Attention: Mr Mark Willich
Application Ref: A006180890
Address of Site: 2929 OLD CLEVELAND RD CHANDLER QLD 4155

RE: Further issues

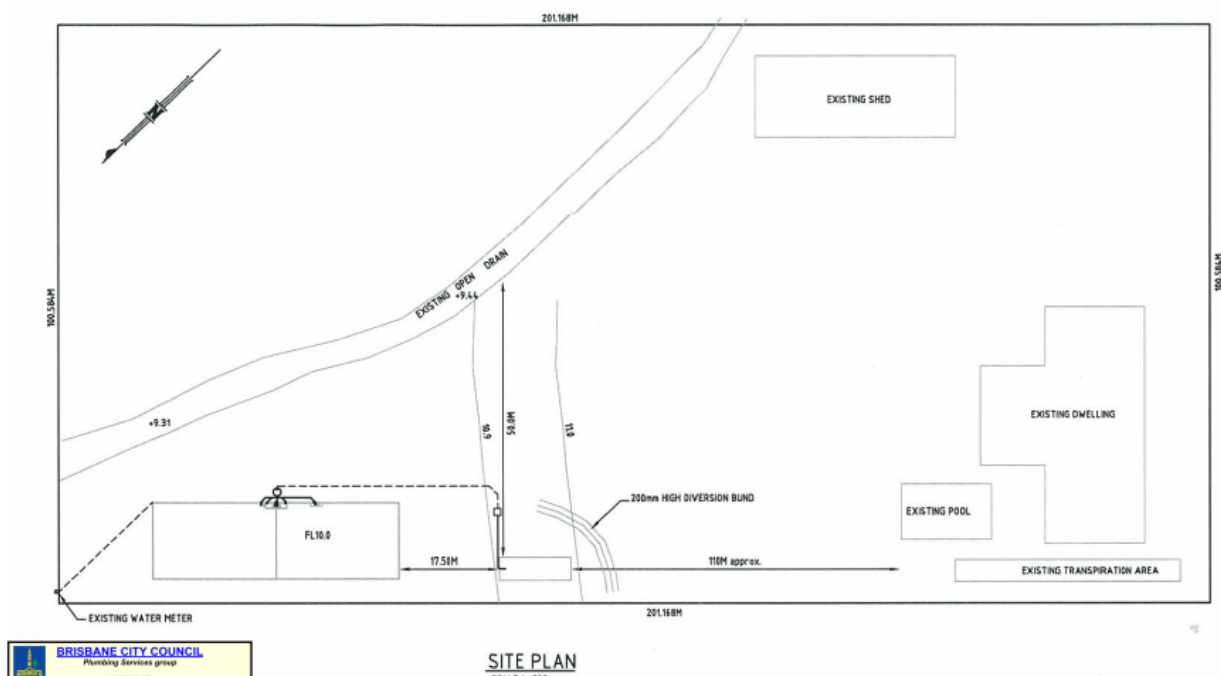
The *Brisbane City Plan 2014* defines the 2002 contour levels of Council's mapping system as natural ground unless a planning approval has been granted to change the land levels. No planning approvals have been granted over the subject site to change these land levels. Below is a comparison of 2002 contours versus 2019 contour levels for the subject site. This overlay demonstrates that filling has been undertaken across the site, including

adjacent to the channel, within the proposed carpark location and adjoining the Tollett Street frontage.

The Storm Water Consulting Flood Overlay Code Assessment Report dated 26 October 2022 modelled the existing extent of flood inundation across the site using the existing site levels. The lawful existing ground land levels are the 2002 contour levels not the existing levels.

- a) Provide an amended flood assessment comparing the 2002 levels with the proposed site levels and identifying where earthworks are being undertaken to restore flood conveyance, demonstrating that the proposal does not directly or indirectly create adverse impact on flood behaviour or drainage on properties that are upstream, downstream or adjacent to the development as required by PO7 of the Flood overlay code.
